Re: Site Closure Report

re: Harbert Transportation, 19984 Meekland Avenue, Hayward, California

2.0 RESPONSE TO TECHNICAL COMMENTS

Site Geologic Cross Sections A-A', B-B' & C-C'
 Former Harbert Transportation
 19984 Meekland Avenue
 Hayward, California

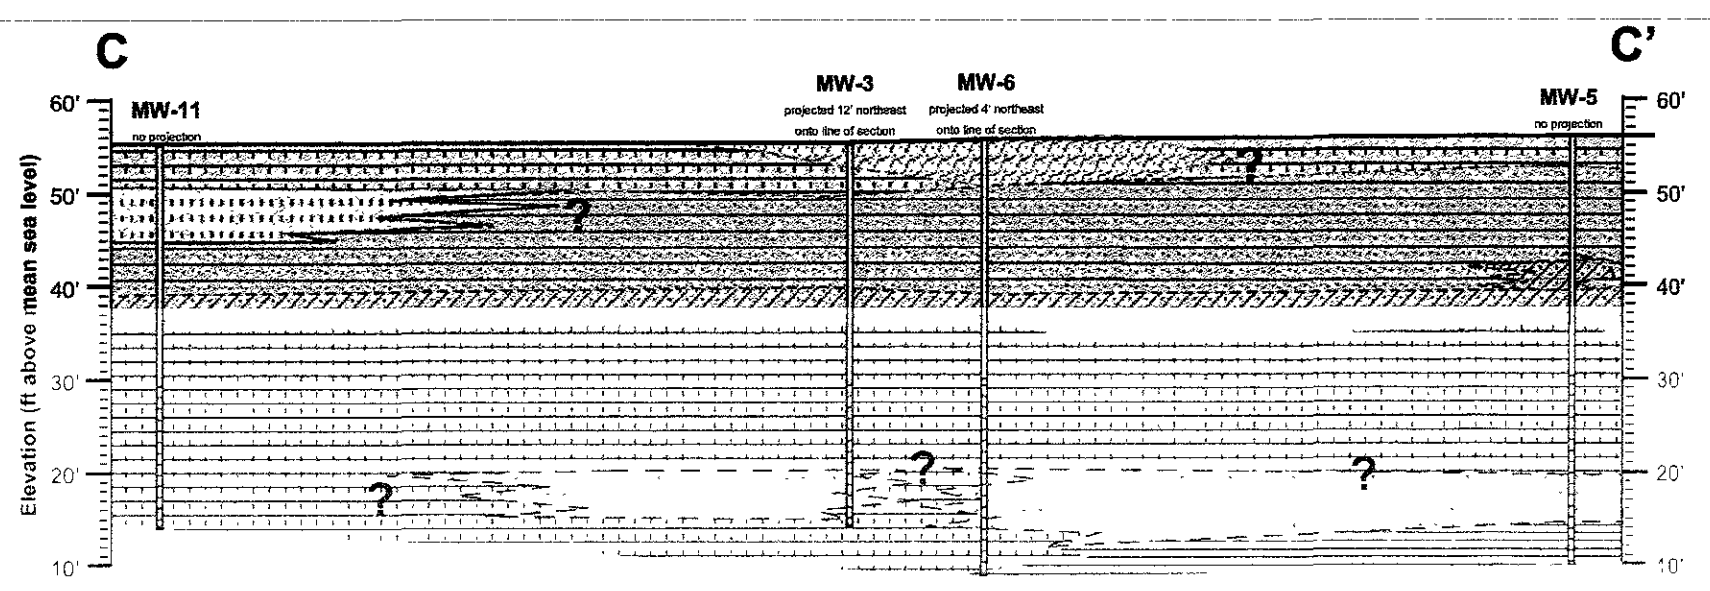
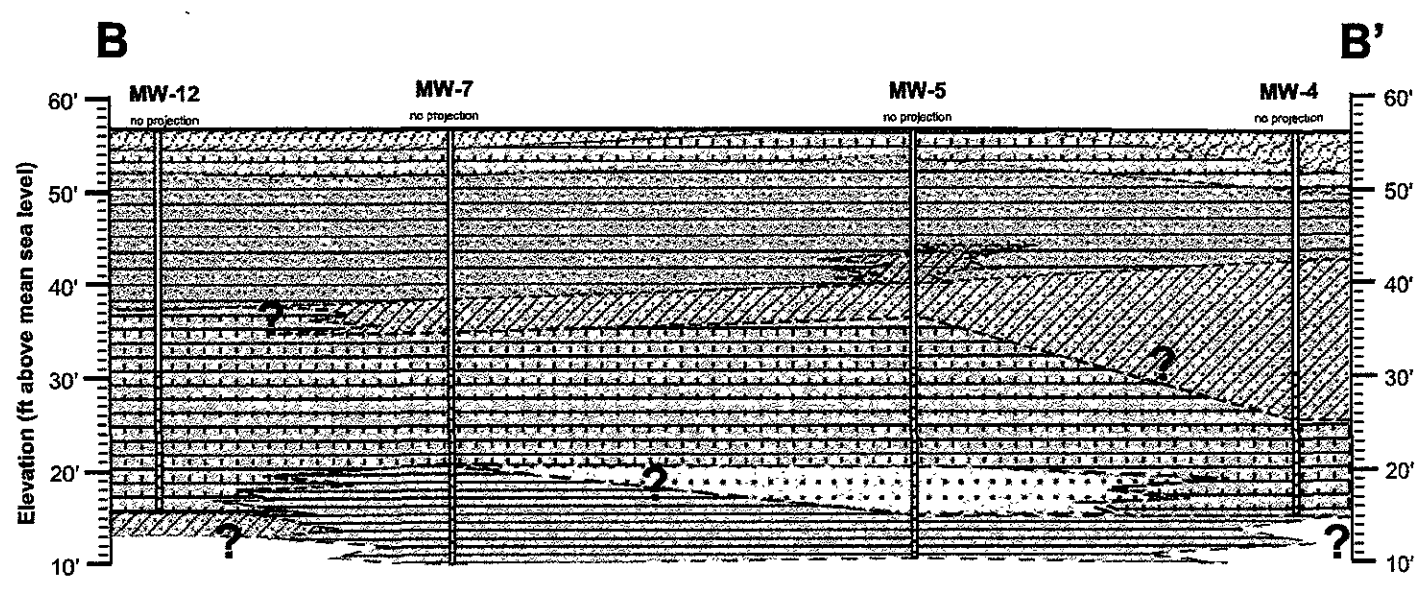
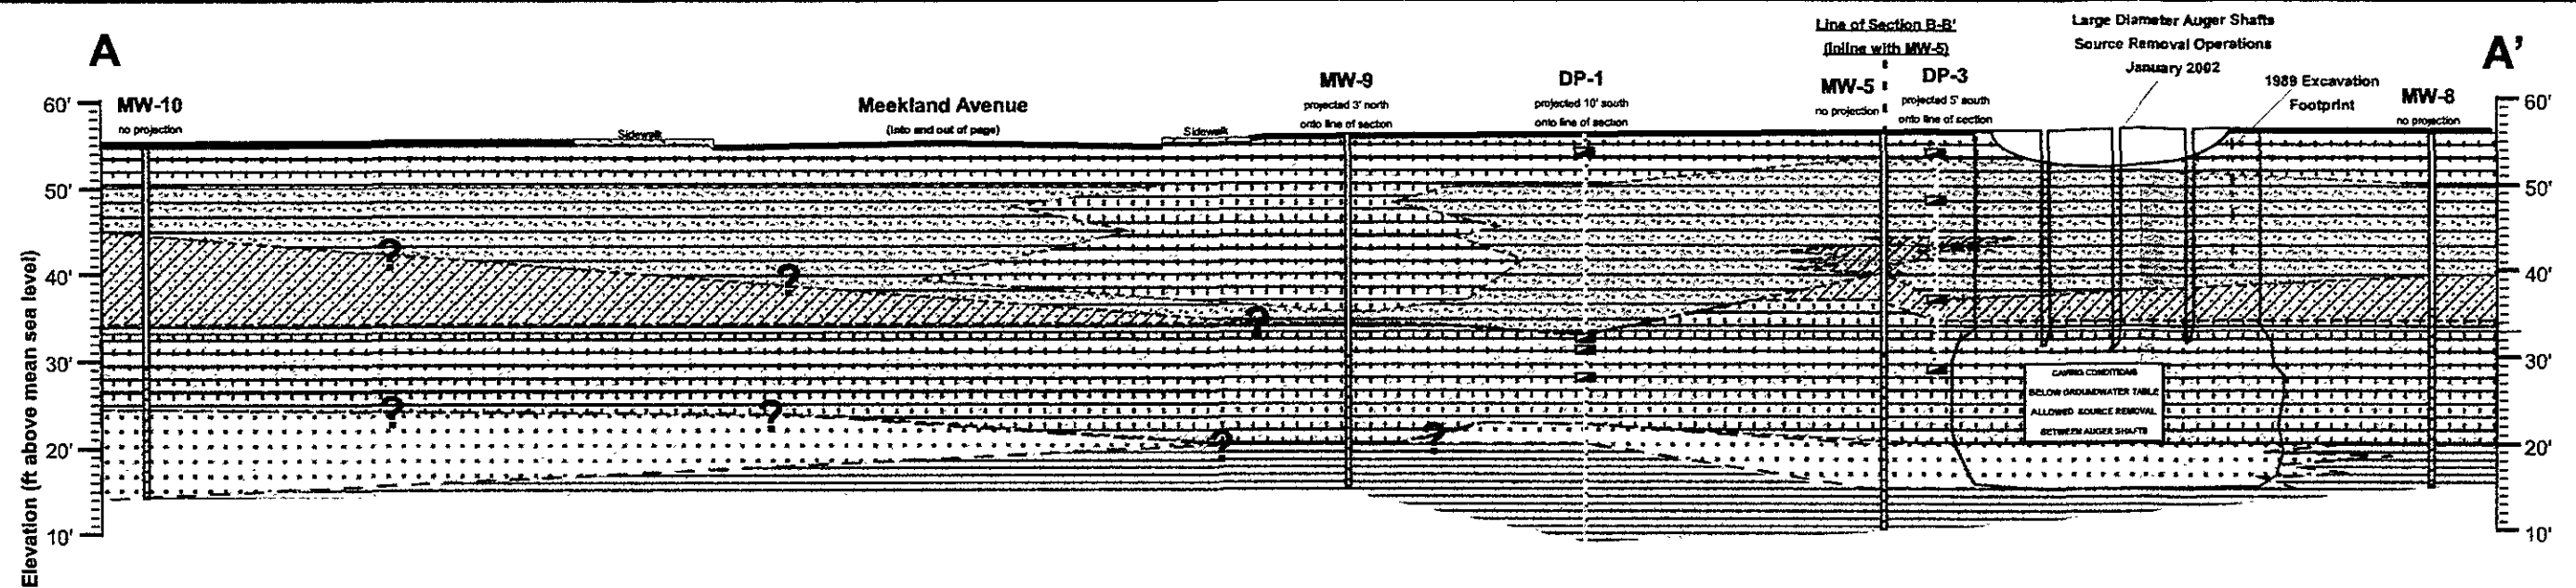
"Until a final evaluation of site lithology is presented to ACEH, we can not review the completeness of lateral definition. Weber-Hayes Cross-section A-A' does not include a location or lithologic results for well MW-9 or boring DP-9. It appears that Figure 2 in your Workplan Addendum (dated January 27, 2005) which presents the cross section trace is significantly changed from the site map and location of cross-section A-A' presented in your July 30, 2004 SCM; however, the cross-section itself is left unchanged....We reiterate our May 13, 2004 request that you revise your maps of the site and correct the discrepancies between your figures. "

Response #3: Comment noted. We have added the lithology from the geologic boring log of MW-9 to the Geologic Cross Section A-A' (see Figure 3). The 1991 log of MW-9 is based on a 5-foot sampling interval, and shows the screened section of this well is in clayey silts (moist and locally sandy) and lean clay. Note: the log of DP-9 (not DP-1) was used to develop cross-section A-A' because DP-1 appears closer to the line of cross section A-A', and was cored to deeper depths (see Figure 2).

The locations of all wells at the site and of fuel dispensers, tank pits and other details were resurveyed on July 14, 2004, by Robert McGregor, Licensed Land Surveyor, to address potential site map discrepancies (the previous well survey had been conducted by CTTS in 1990). The new survey was used to improve our site map, and is the basis for all the site maps included in WHA 2005 reports. The overall cross section length was adjusted approximately 11 feet in length on A-A', and lesser amounts on B-B' and C-C' to match the well locations shown on the new site map. There is no change in the subsurface lithology interpretation. The lateral definition of the site has been completed.

Site Map & Vicinity
Former Harbert Transportation Facility
19984 Meekland Avenue
Hayward, California

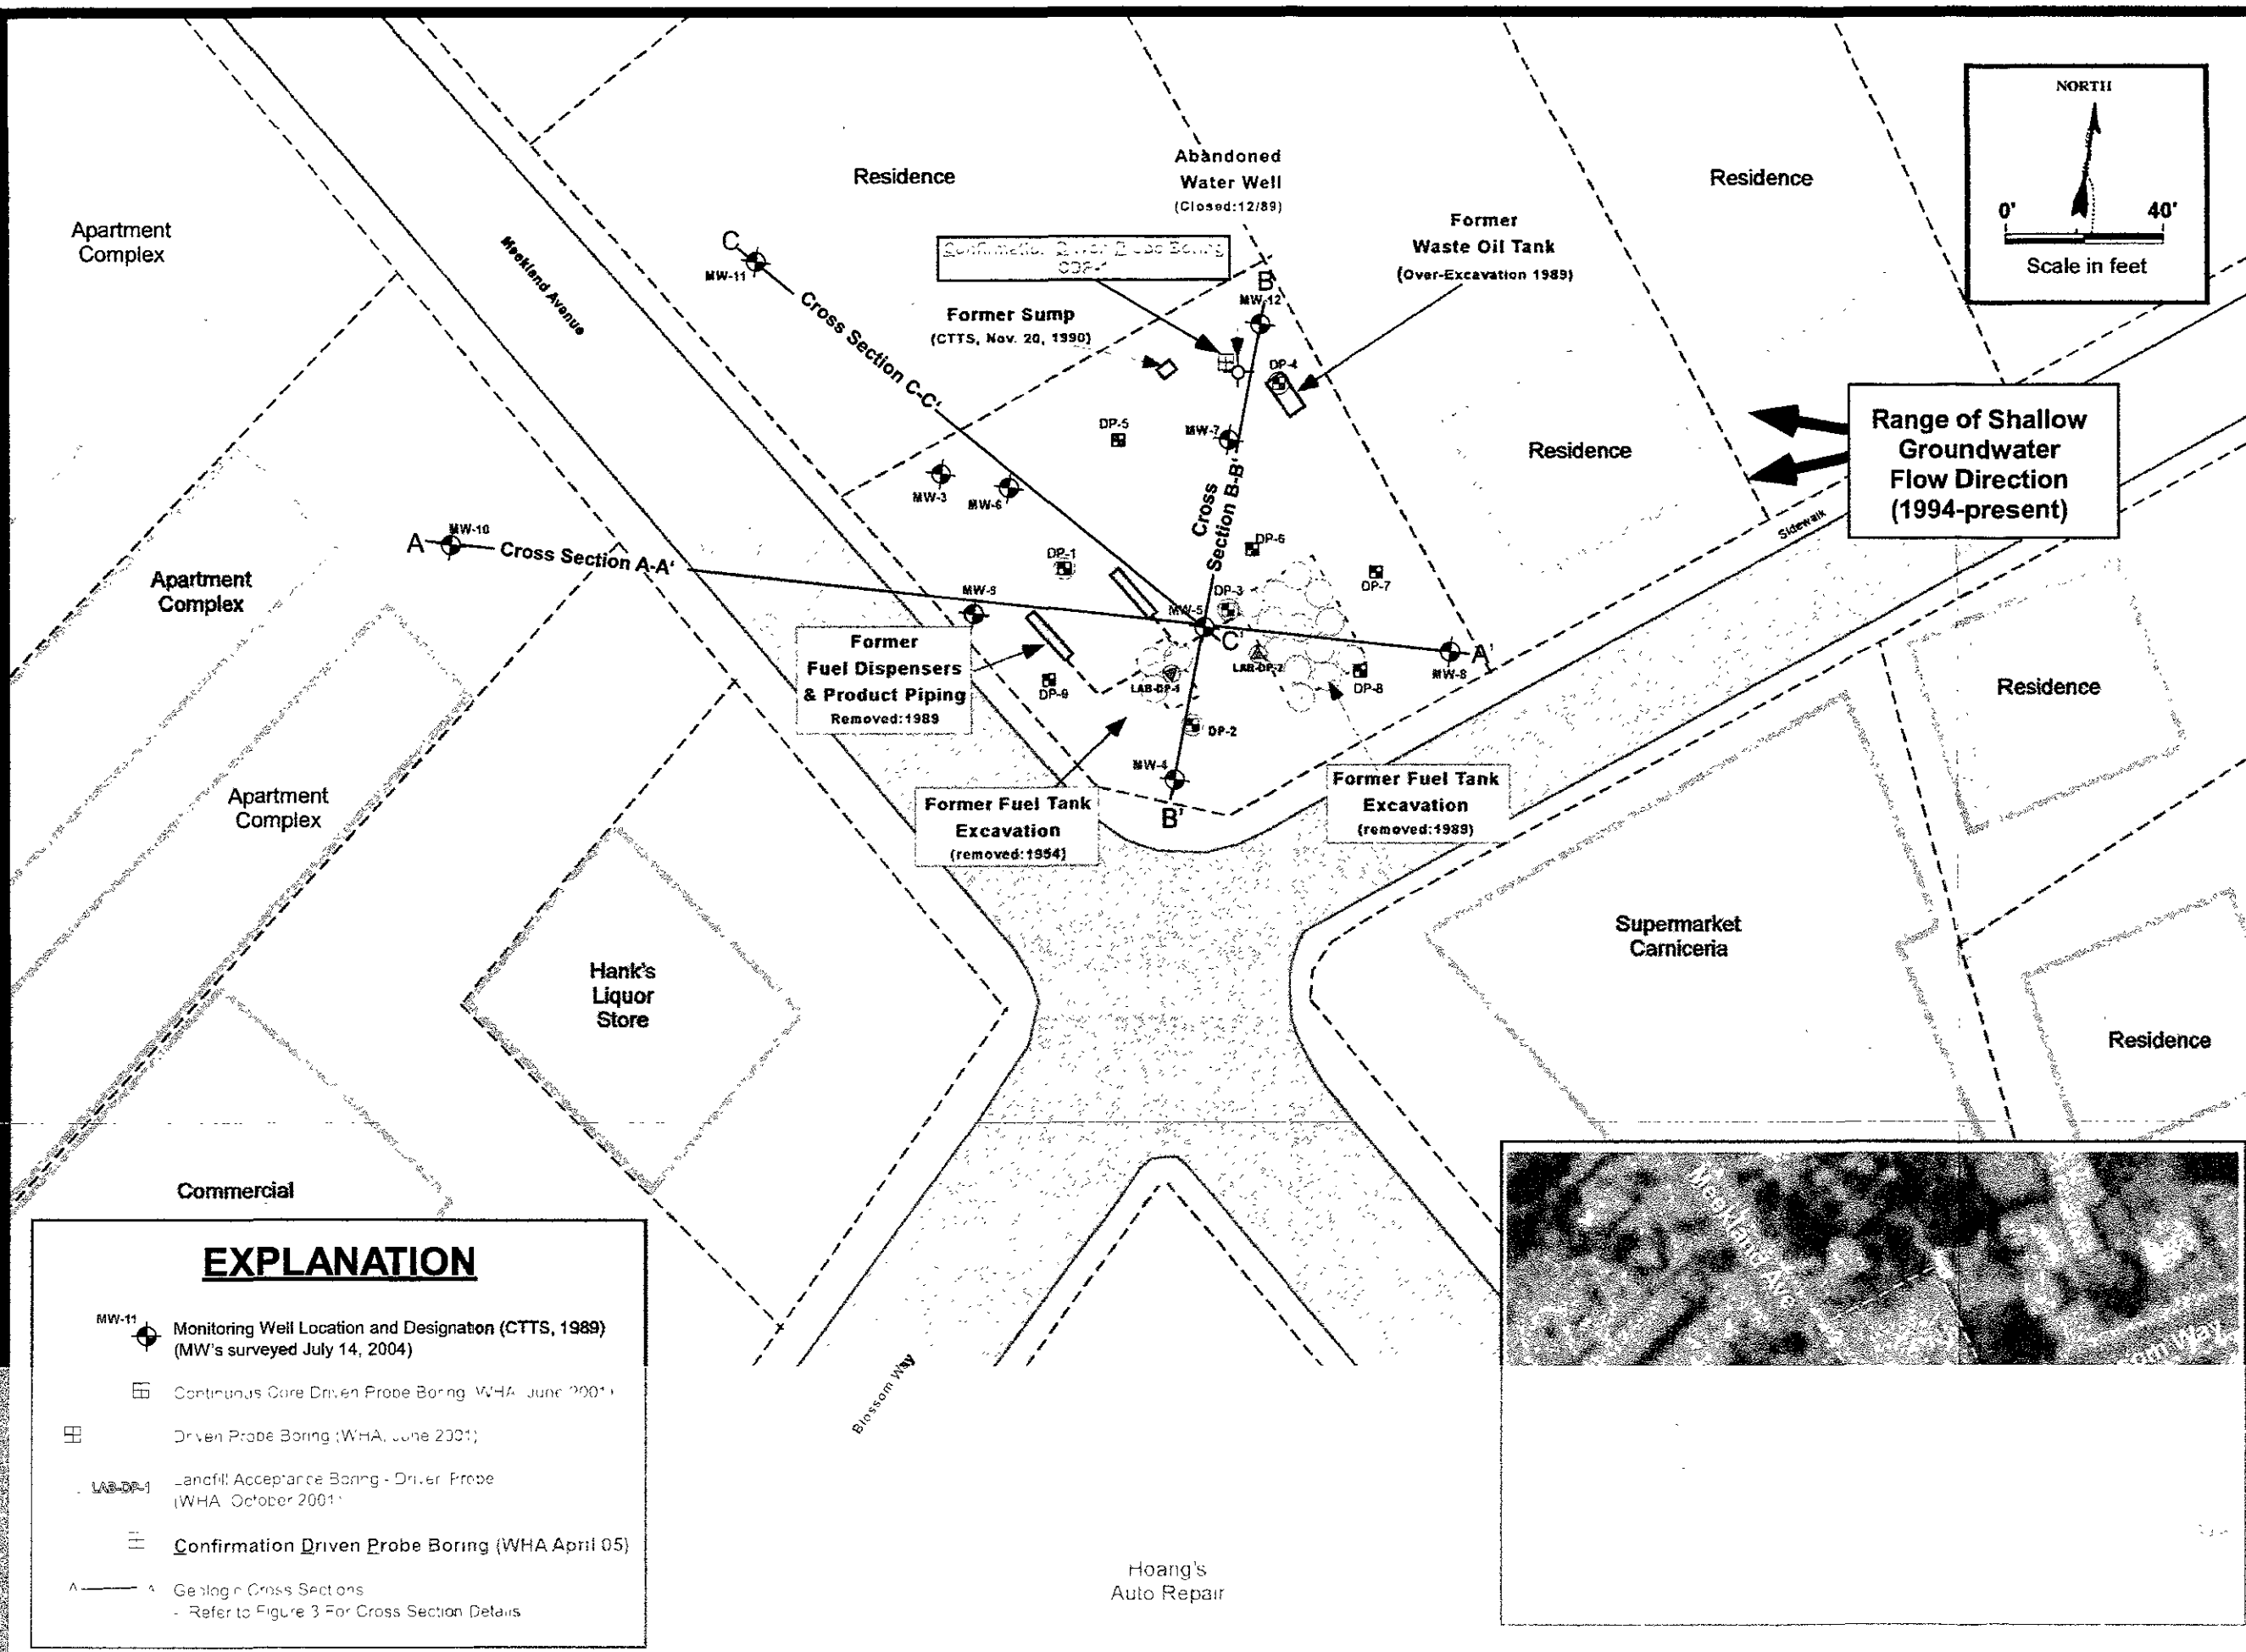
A) **Relative Location of Wells and former UST System:** *"Figure 2 of your Workplan Addendum is significantly different from previous depictions. In previous maps well MW-9 was downgradient of the former UST system; however, the site layout presented in Figure 2 of the Workplan Addendum suggests that no sampling has been performed downgradient of well MW-5 and the source area"*

#2A Response: The details were resurveyed on July 14, 2004, by Robert McGregor, Licensed Land Surveyor, to provide confirmation information on the locations of all wells, fuel dispensers, and tank pits previously requested in the ACEH Technical Comments, dated December 2, 2004. The new survey was used to improve our site map, and is the basis for all the site maps included in WHA 2004 and 2005 reports (the previous well survey had been conducted in 1990 by CTTS). The re-survey documented a slight change in the outline of the property and the relative placement of monitoring wells but no change in the position of monitoring wells relative to the former UST tank, or relative to the groundwater flow direction. In summary, the wells remain in the same groundwater flow position relative to each other and relative to the source of the fuel release.

The range of groundwater flow direction is northwesterly to southwesterly as calculated from water level measurements obtained between 1994 to the present (see Figure 2). Monitoring well MW-5 is located adjacent to the former UST tank pit on the downgradient side. In 10+ years of groundwater elevation measurement, groundwater flow has consistently been northwesterly to southwesterly, towards on-site wells MW-4 and/or MW-9 and off-site well MW-10. These three monitoring wells provide high-quality downgradient coverage of the former Underground Storage Tank (UST) release (MW-4, 5, and 9), and abundant downgradient groundwater sampling data (see Table 1).

It should be noted that the 2004 resurvey established the previously undefined property boundaries. An earlier round of driven probes borings (DP-1 through DP-9 drilled in 2001) were inaccurately labeled on previous maps, based on non-surveyed distances from fences. The locations of these DP borings have been adjusted based on the new survey, resulting in a slight shift in several DP locations relative to earlier maps (shown on Figure 2). NOTE: this did not change any lithologic interpretations or conclusions on the subsurface extent or absence of contamination.
